Appl. No. 10/531,696  
Amdt. dated December 22, 2006  
Reply to Office action of September 27, 2006

**AMENDMENTS TO THE DRAWINGS:**

**REMARKS**

Fig. 1

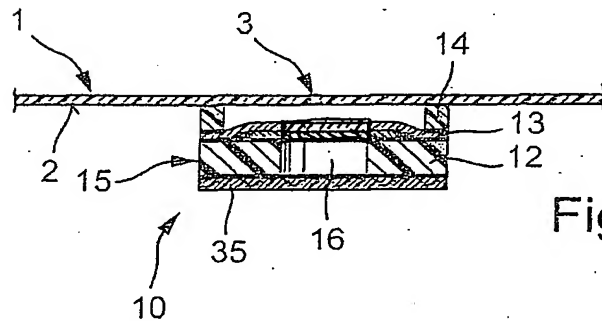
The drawings have been objected to because the passage opening (16) in the base plate is shown in Fig.1 to extend through the diaphragm (13), but Fig. 3 does not show that feature. Fig. 1 has been corrected to show that the passage opening (16) in the base plate does not extend through the diaphragm (13). In view of the correction to the drawings, withdrawal of the objection is requested.

The attached sheet of drawings includes changes to Fig. 1 and replaces the original sheet including Figs. 1-5. Fig. 1 has been corrected to show that the passage opening (16) in the base plate does not extend through the diaphragm (13).
